50-245

PROPOSED TECHNICAL SPECIFICATION CHANGES FOR MILLSTONE UNIT  
NO. 1, RELOAD 8

## 1. Reload 8/Cycle 9 Work and Extended Load Line Limit Evaluation

Figure 3.11.1a - MAXIMUM AVERAGE PLANAR LINEAR HEAT GENERATION RATE (MW/CM<sup>2</sup>) VERSUS PLANAR AVERAGE EXPOSURE. FUEL TYPE 808262.

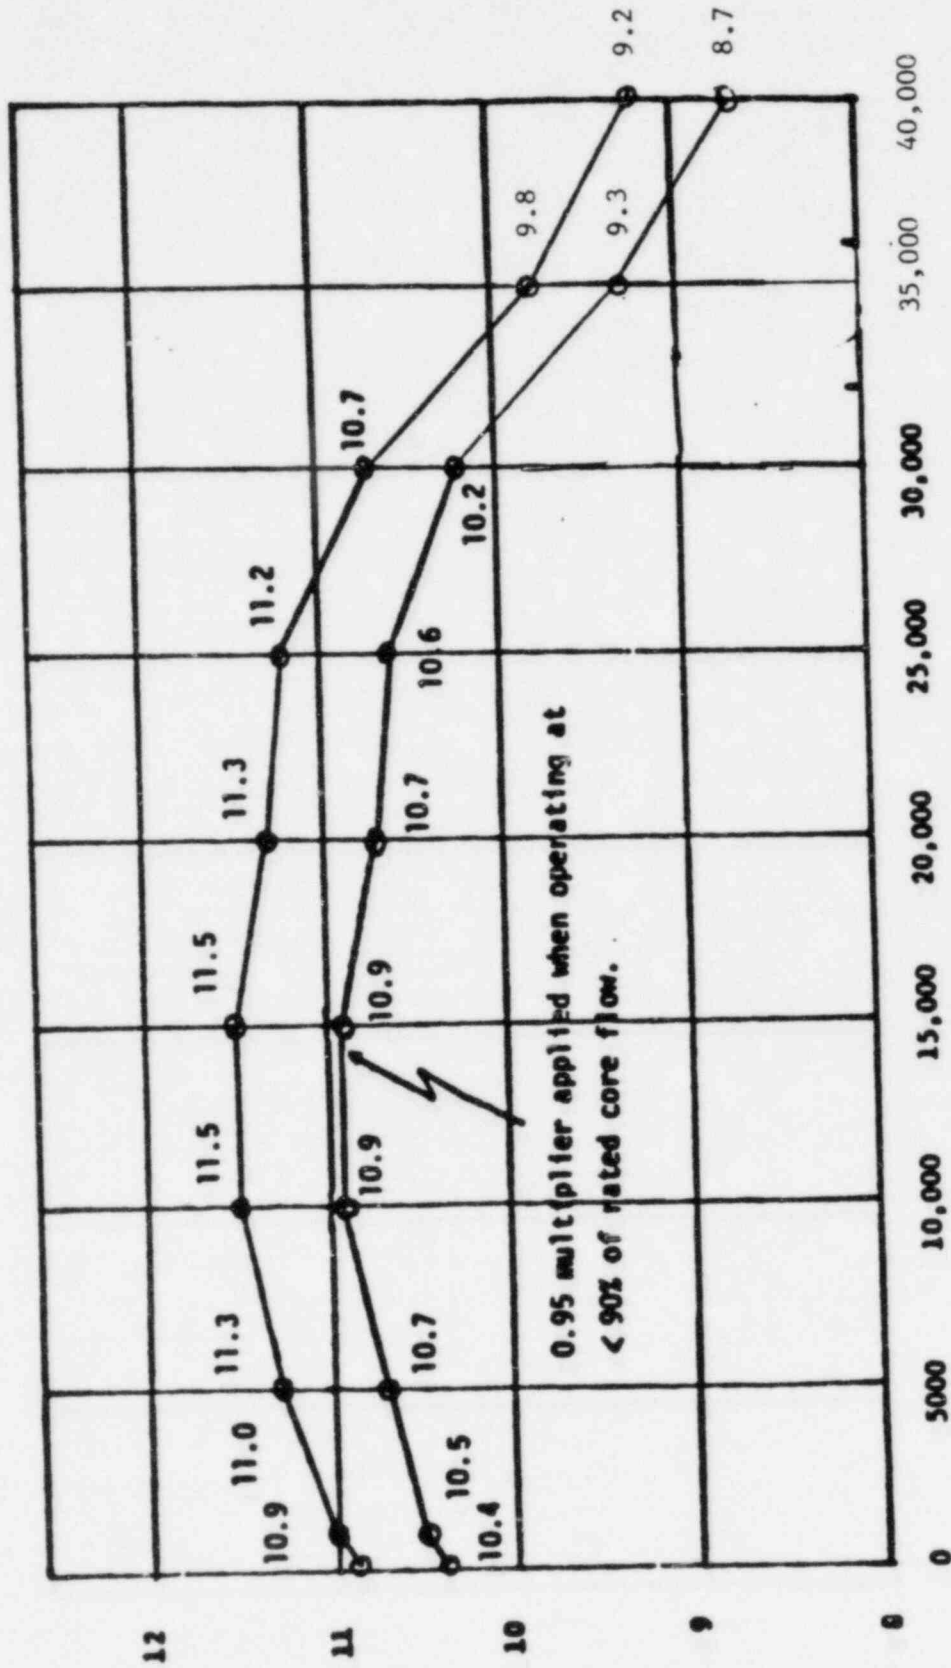
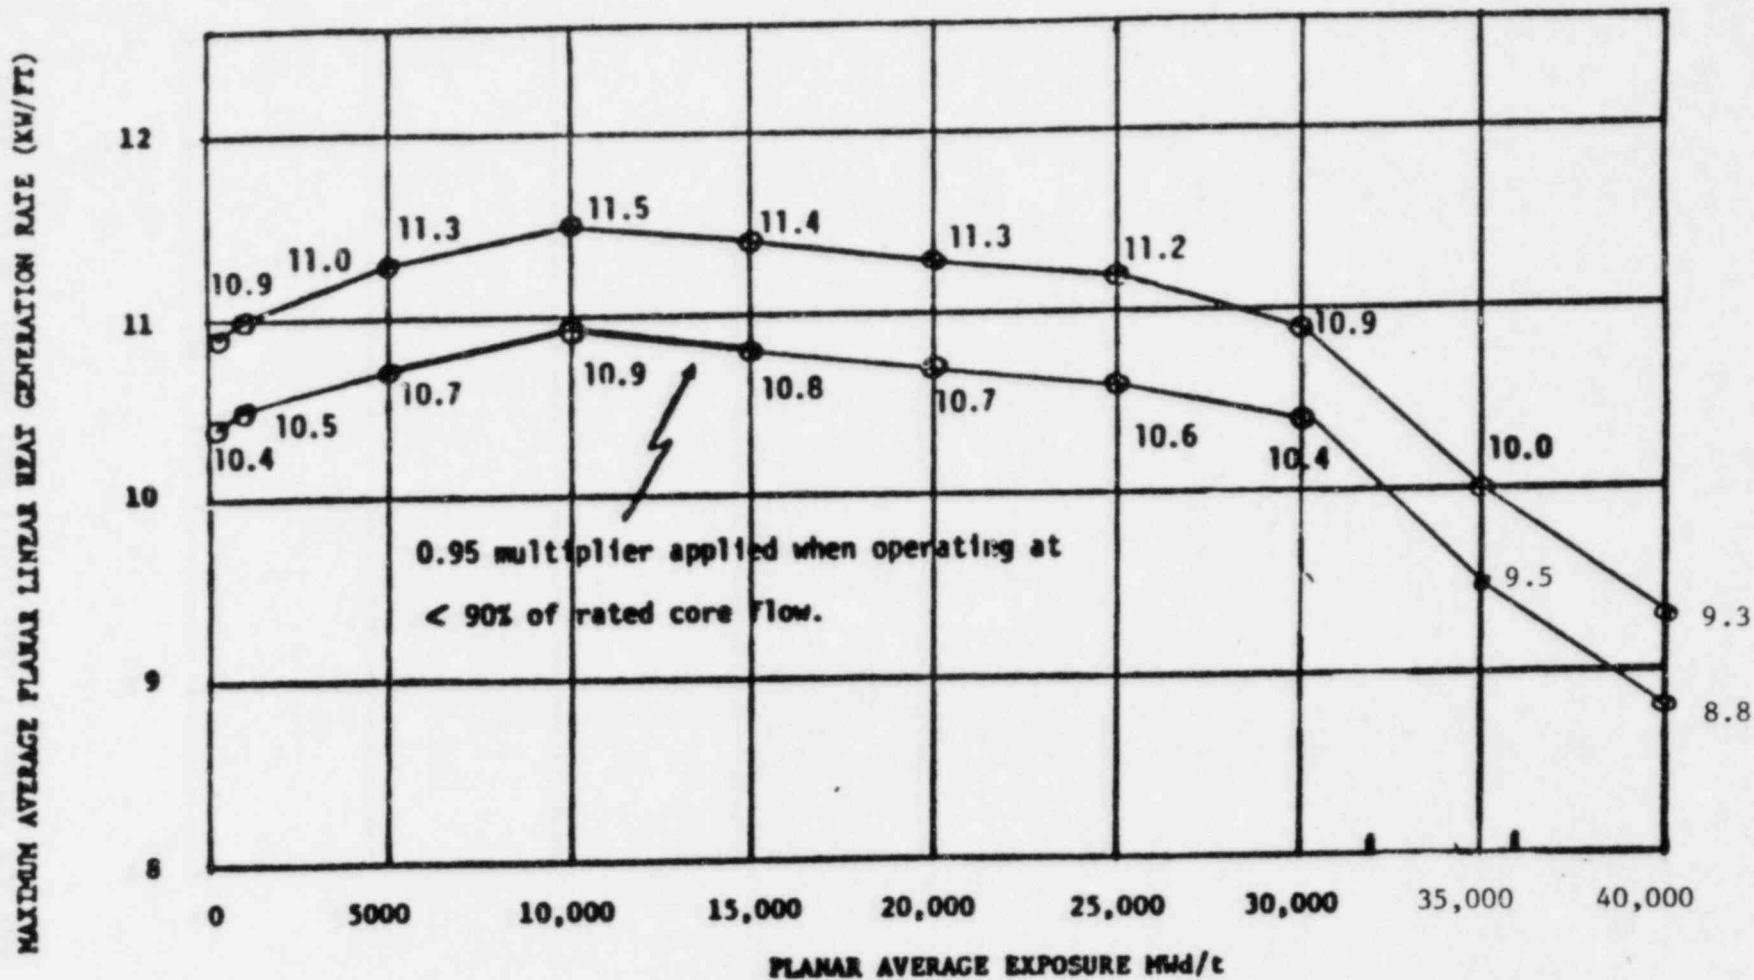
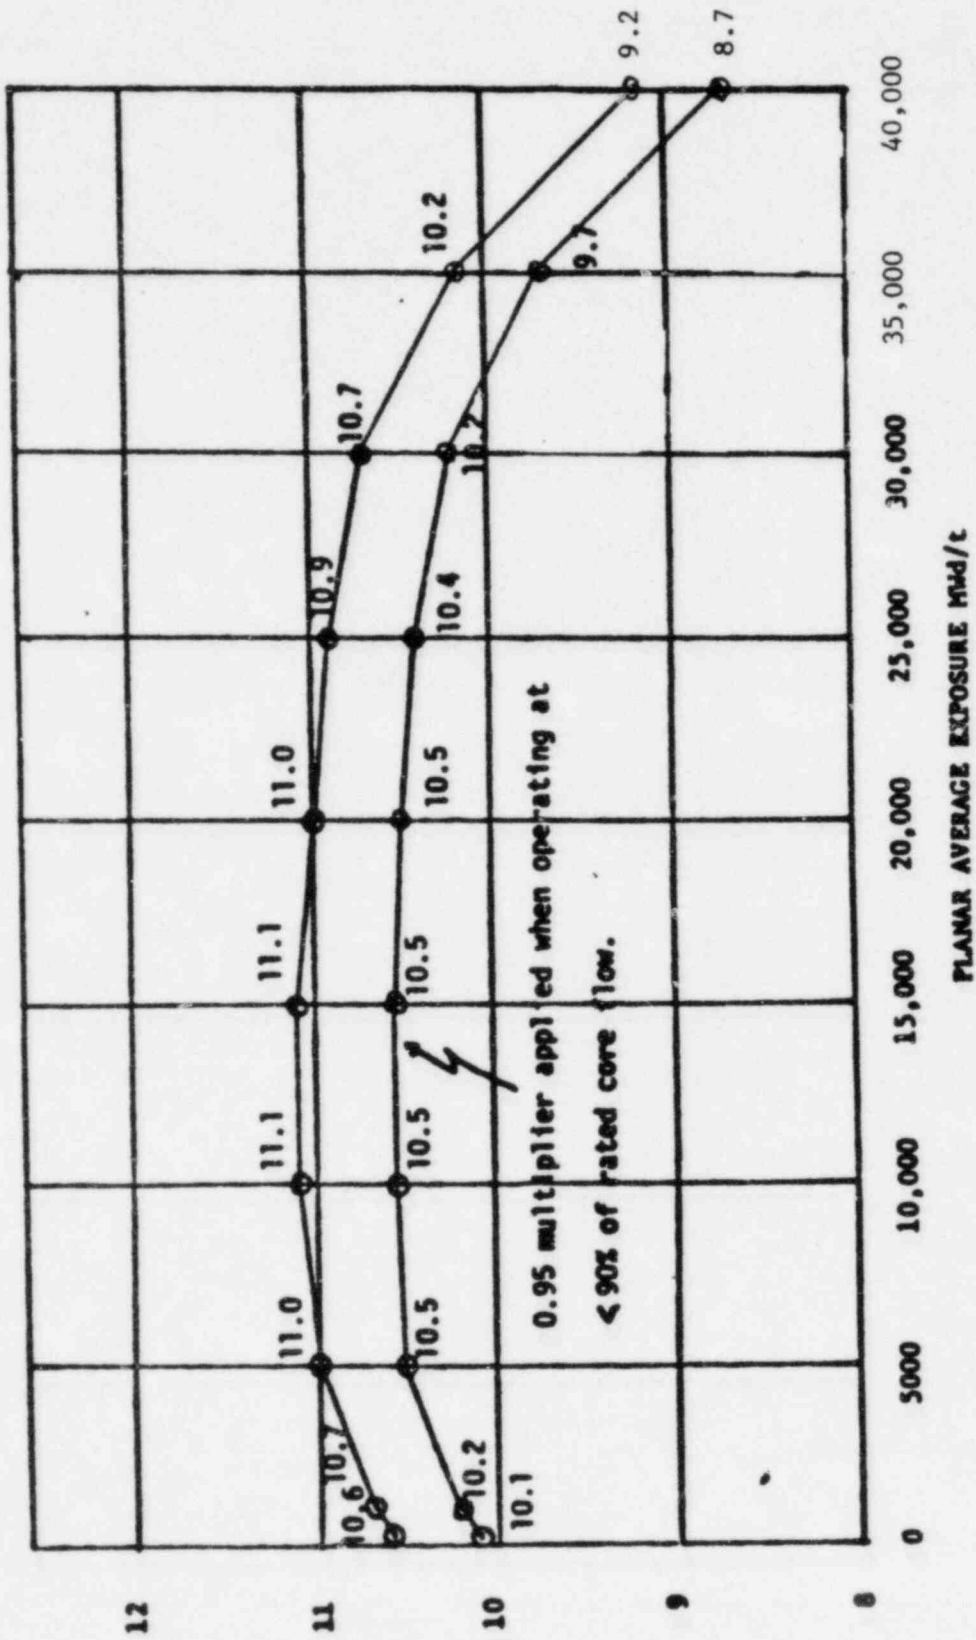
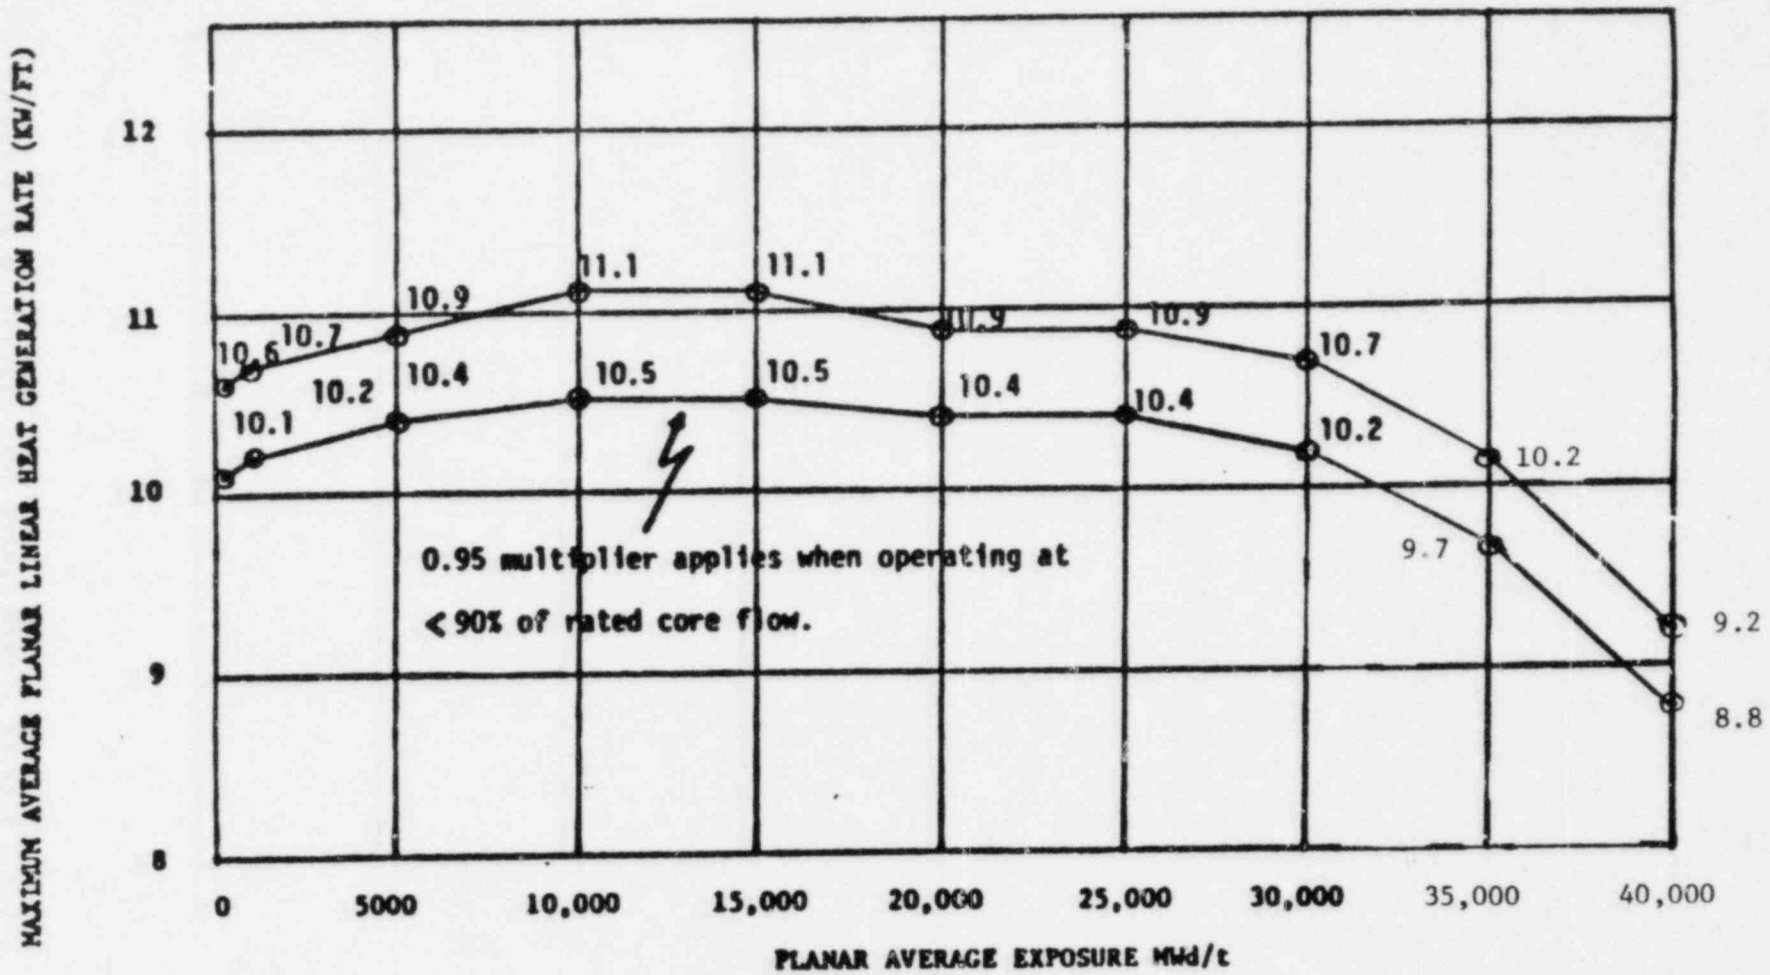
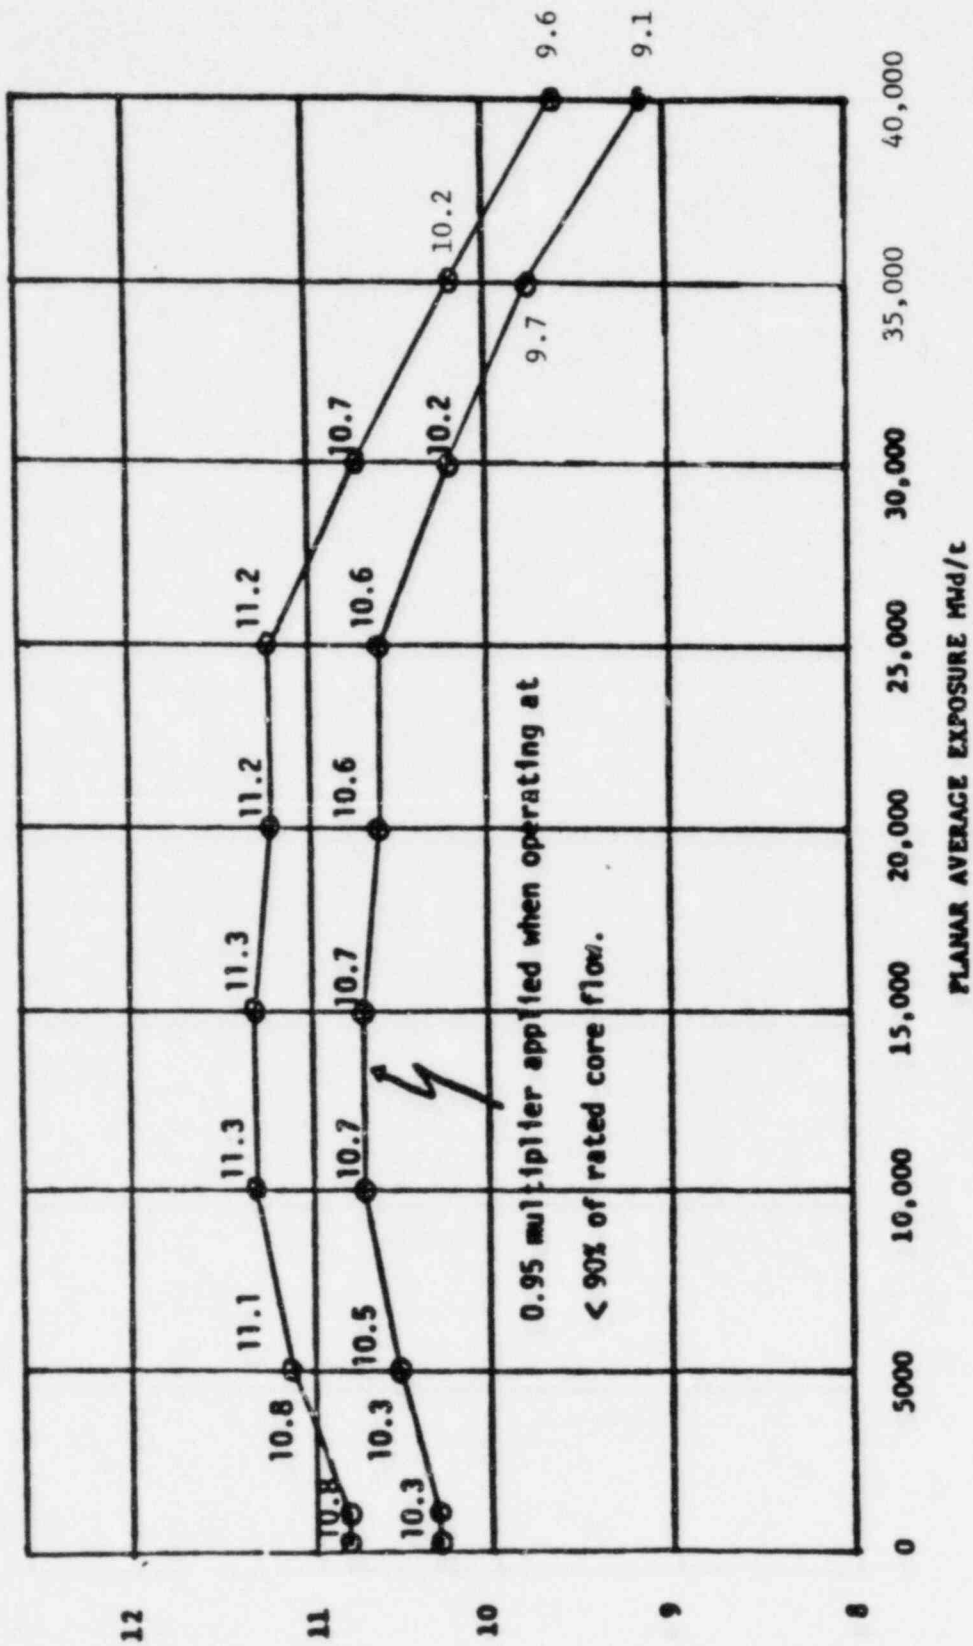
- a. Figure 3.11.1 - This figure represents the exposure dependent Maximum Average Planar Linear Heat Generation Rate (MAPLHGR) for the different fuel types at Millstone Unit No. 1. Each fuel type has its own curve which is based on the LOCA analysis performed for Millstone Unit No. 1. In Reload 8/Cycle 9, we have deleted one fuel type (8D274L) and added one fuel type (P8DRB283). Figure 3.11.1 was also revised to reflect the removal of the high burnup MAPLHGR limits previously imposed by the NRC due to fission gas concerns. The removal of these limits was approved on a generic basis (Generic Letter 82-03) on March 31, 1982 in a letter from Darrell G. Eisenhut to All Operating BWR's.
